3.2**39 Austin Avenue, North Curl Curl – Construction of a Dwelling House Including Ancillary Site Works****DEVELOPMENT ASSESSMENT REPORT**

Assessment Officer:	Alex McDougall
Address / Property Description:	Lot 66 DP 6143, No. 39 Austin Avenue, North Curl Curl Demolition works and construction of a dwelling house including ancillary site works
Development Application No:	DA2010/1445
Application Lodged:	09/09/2010
Plans Reference:	A00-A15, dated 27/8/10, by Sanctum Design Pty Ltd
Amended Plans:	N/A
Applicant:	Sanctum Design Consultants Pty Ltd
Owner:	P N James, E K Fordham
Locality:	F5 Curl Curl
Category:	Category One ('Housing')
Draft WLEP 2009 Permissible or Prohibited Land use:	R2 – Low Density Residential Permissible
Variations to Controls (Cl.20/Cl.18(3)):	Rear Building Setback, Side Boundary Envelope
Referred to ADP:	YES (5 unresolved objections)
Referred to WDAP:	NO
Land and Environment Court Action:	NO
SUMMARY	
Submissions:	Five (5) Unresolved
Submission Issues:	Side Boundary Envelope, View Loss, Solar Access, Privacy, Trees, Building Bulk, Roofs, Building Height, Unclear Plans, Devaluation

Assessment Issues:	Rear Building Setback, Side Boundary Envelope, View Loss, Privac

Site and Elevation Plans

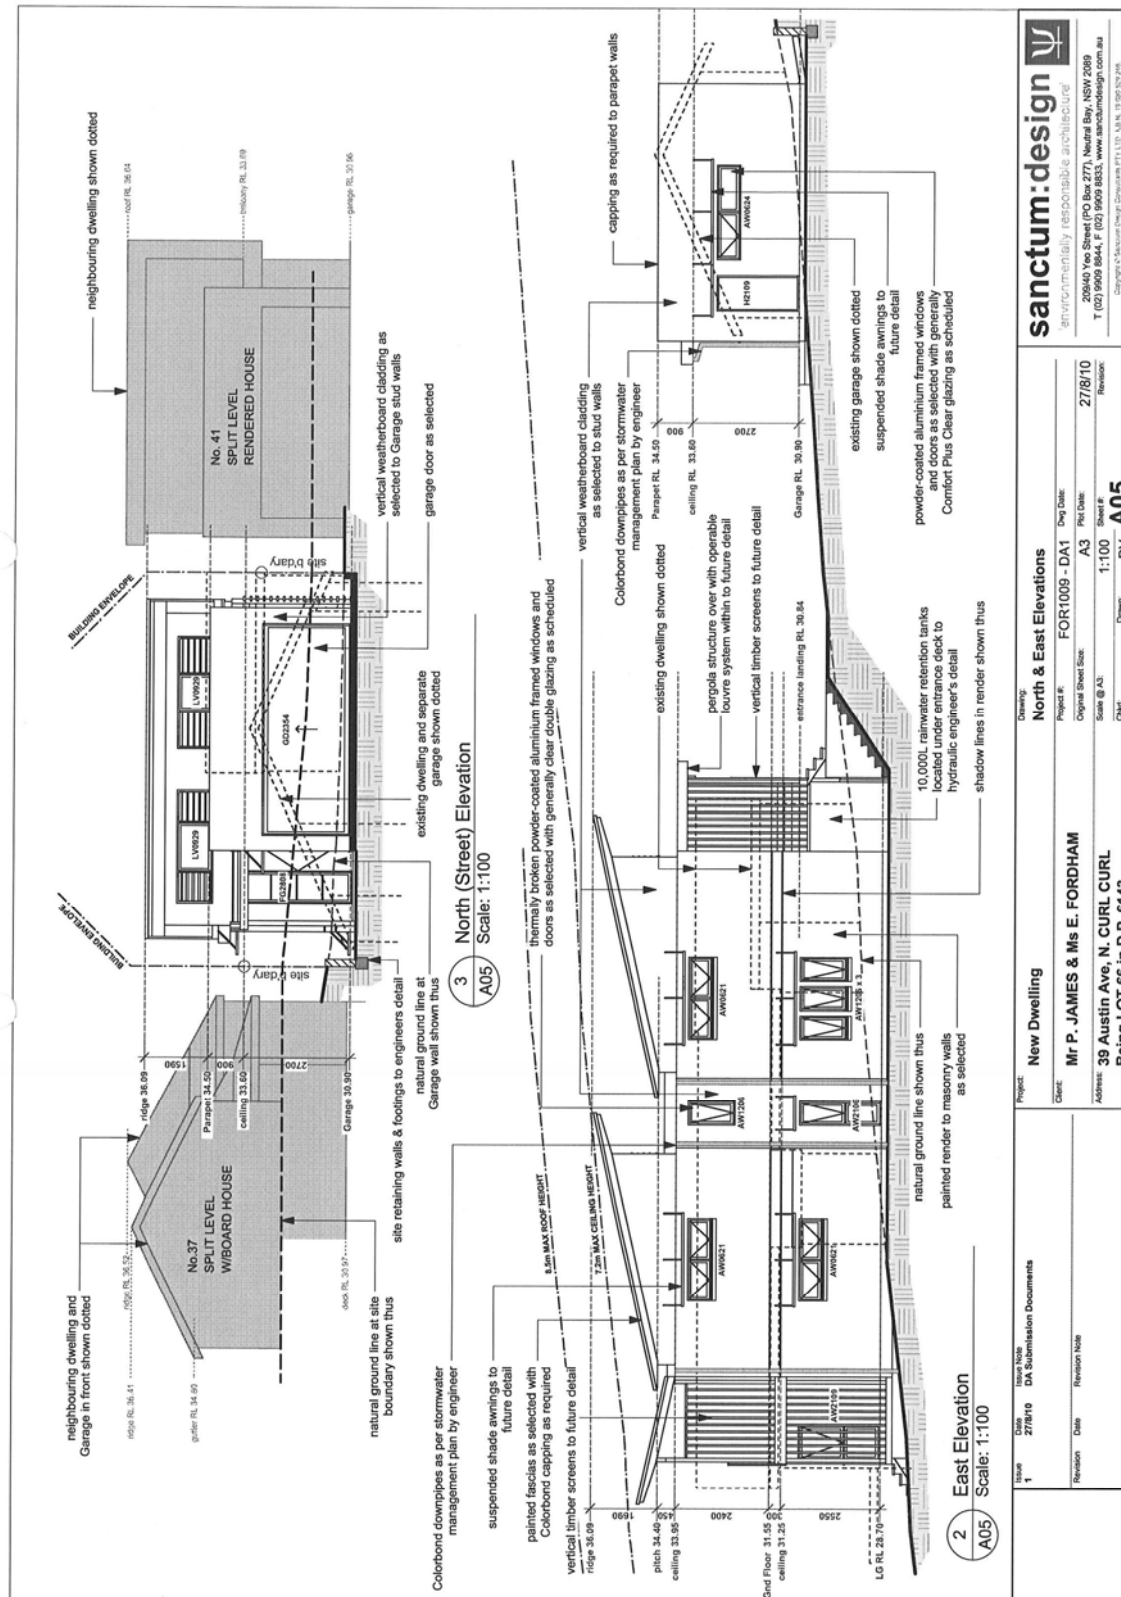
Proposed: 2.5m (to roofing), 3.6m (to wall planes)

Comment: The proposal, in being only 2.5m from the rear setback, and the rear façade being up to 7m in height, fails to maintain a sense of openness in the rear yard.

Privacy: The breach of the rear setback results in a kitchen window looking down on the primary private open space of the adjoining property to the west.

Visual Bulk: The proposal results in a reduction in amenity for the property to the west by creating a sense of enclosure and visual bulk on its rear yard.

Proposed: Side Boundary Envelope Breach Western elevation (Max Height of 1.0m, Total Length of 8.7m), Eastern elevation (Max Height of 0.7m, Length of 4.2m).

Comment: The proposal will not be visually dominant by virtue of its height and bulk when viewed from Austin Avenue as it is significantly setback from the front boundary. However, the breach in the side boundary envelope, especially to the rear western side of the site, is directly adjacent to the rear deck and yard of No. 41 Austin Avenue. As such these breaches serve to exacerbate the feeling of visual bulk and enclosure on this adjoining property and is considered to be unacceptable.

Comment: The side boundary envelope breach is most extensive to the rear western side of the proposed dwelling and results in a seven (7) metre wall plane directly adjacent to the rear private open space of the neighbouring dwelling to the west at No. 41 Austin Avenue. As such, the proposal fails to maintain a sense of openness.

The proposed development significantly breaches the rear building setback of the locality creating unnecessary and avoidable amenity impacts on adjoining and nearby properties. The breach of the rear setback and side boundary envelope results in a sense of enclosure both on the rear yard of the subject site and adjoining properties. Additionally, the orientation of the proposal towards the rear of the site results in unreasonable privacy impacts. While the breach of the rear setback does not significantly affect the view of adjoining properties, the subject site would enjoy the same views were it to be setback the required six (6) metres.

1. Pursuant to Section 79C(1)(a) of the Environmental Planning and Assessment Act 1979 the proposed development is inconsistent with Clause 12(2)(b) and fails Clause 20(1) of Warringah Local Environment Plan 2000 (as amended) in that the proposed development is inconsistent with the rear building setback and side boundary envelope development standards detailed under the applicable Built Form Controls for the F5 Curl Curl Locality. In this regard it is considered that the failure to comply with the development standard will:

- Not conform with the predominant rear building setback in the street,
 - Result in visual bulk when viewed from adjoining properties,
 - Sets an undesirable precedent for development,

2. Pursuant to Section 79C(1)(a) of the Environmental Planning and Assessment Act 1979 the proposed development is inconsistent with Clause 12(1)(a) and Clause 18(1) of Warringah Local Environment Plan 2000 (as amended) in that portions of the proposed development are inconsistent with the General Principles outlined under Part 4 of WLEP 2000 as follows:

- Clause 63A – Rear Building Setback
 - Clause 65 – Privacy
 - Clause 66 – Building Bulk
3. Pursuant to Section 79C(1)(e) of the Environmental Planning and Assessment Act 1979 the proposed development is not in the public interest in that:
